**Rancho Las Virgenes
Regional Facilities Expansion IV**

Solids Handling and Composting Facilities

LAS VIRGENES MWD / TRIUNFO CSD
RANCHO LAS VIRGENES - REGIONAL FACILITIES EXPANSION IV
SOLIDS HANDLING AND COMPOSTING FACILITIES

ANAEROBIC DIGESTERS AND
 DIGESTER PUMP STATION

PRESSURE RELIEF VALVE F
 SCALE: 1/2" = 1'-0"
 (1 REQUIRED/DIGESTER)
 IM-2

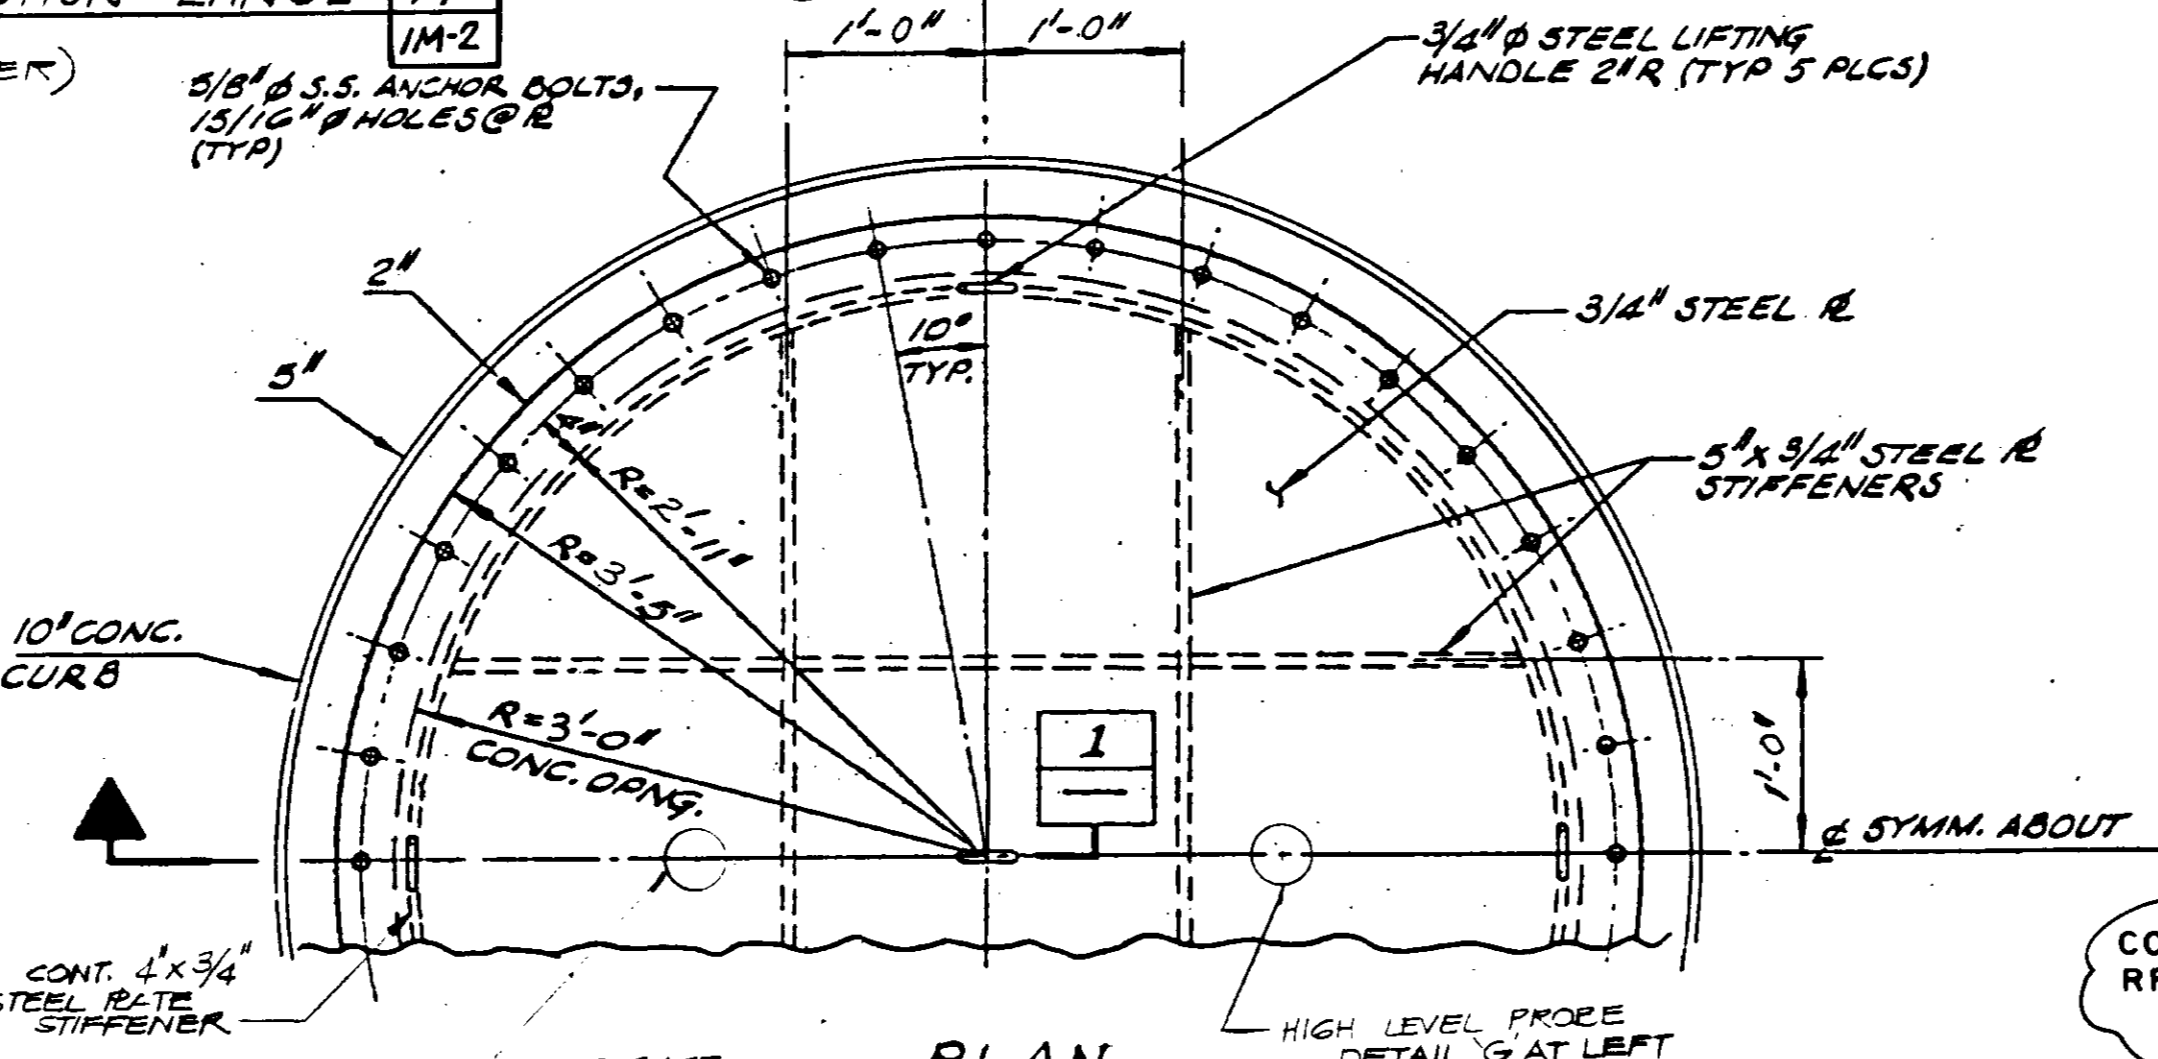
PLAN NTS
 CORRECT PER RFI # 542

SHEET
6M-3
OF 508 SHEETS

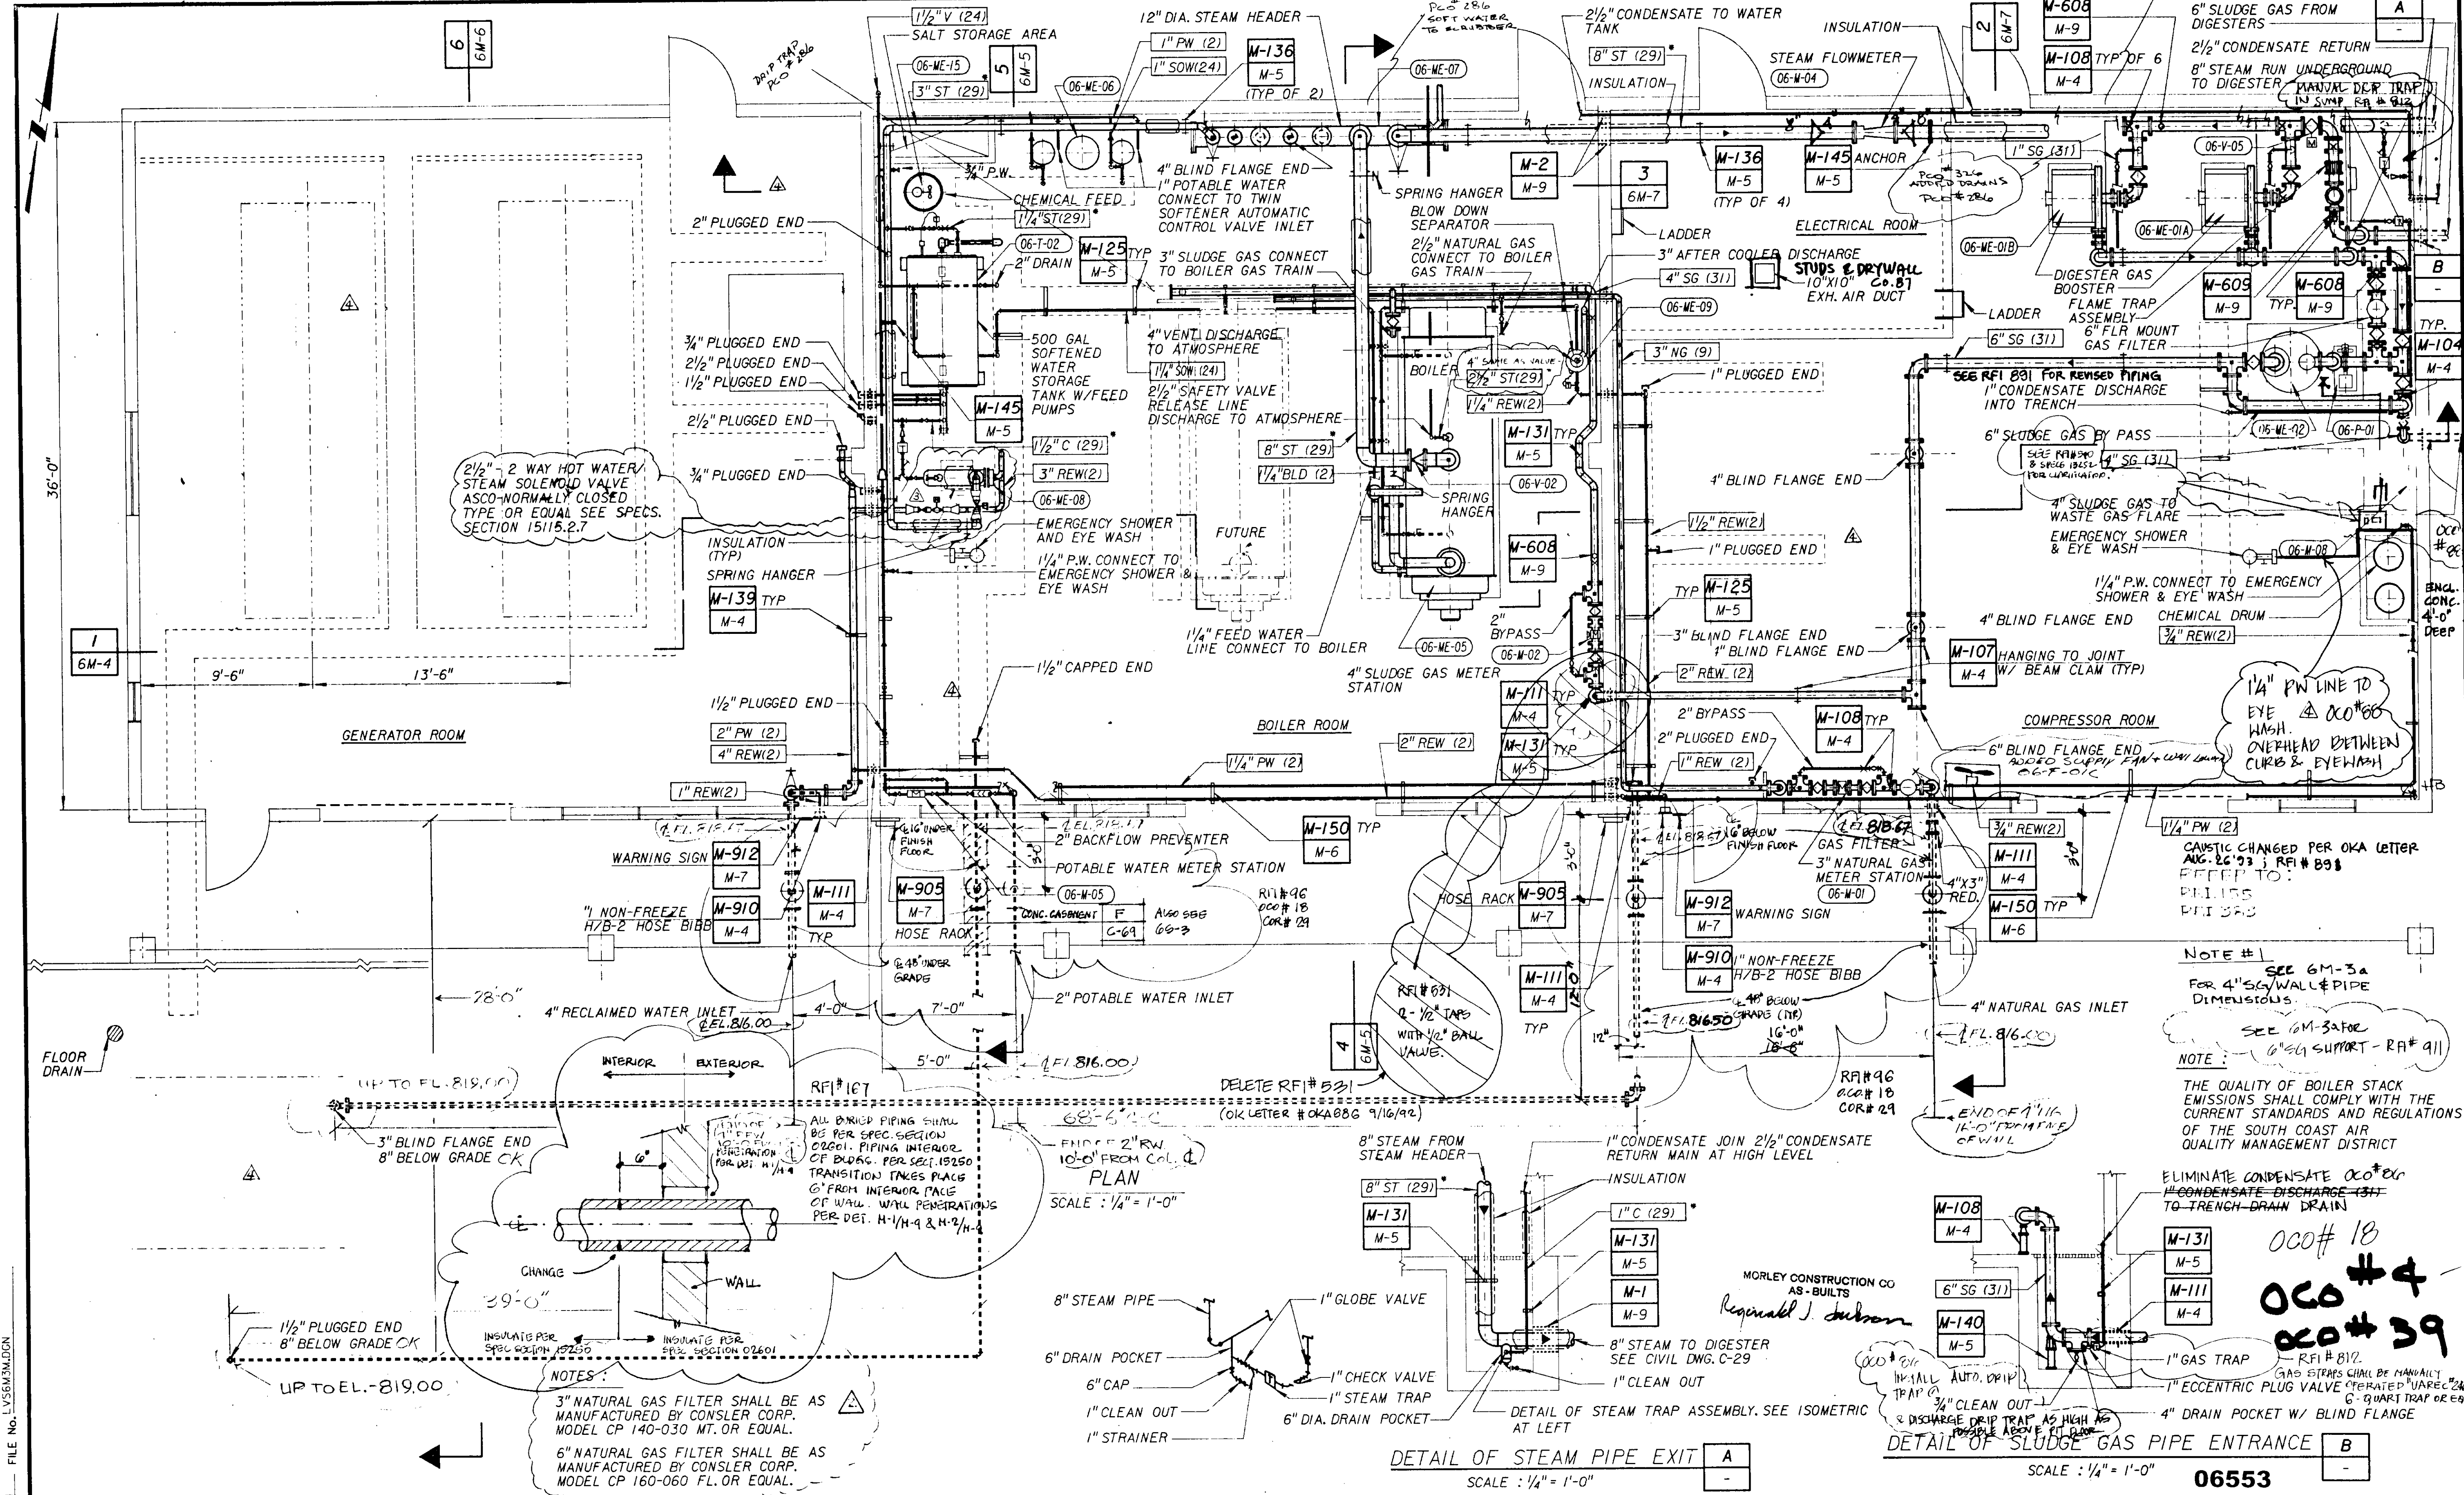
NOTE #1
SEE 6M-3a
FOR 4" SG/WALL PIPE DIMENSIONS.
NOTE: SEE 6M-3a FOR 6" SG SUPPORT - RA# 911

ELIMINATE CONDENSATE 000# 26
CONDENSATE DISCHARGE (311) TO TRENCH-DRAIN

RFI # 812
GAS STRAPS SHALL BE MANUALLY OPERATED UNLESS OTHERWISE SPECIFIED IN SPEC. 19250
6" GUARD TRAP OR EQ.
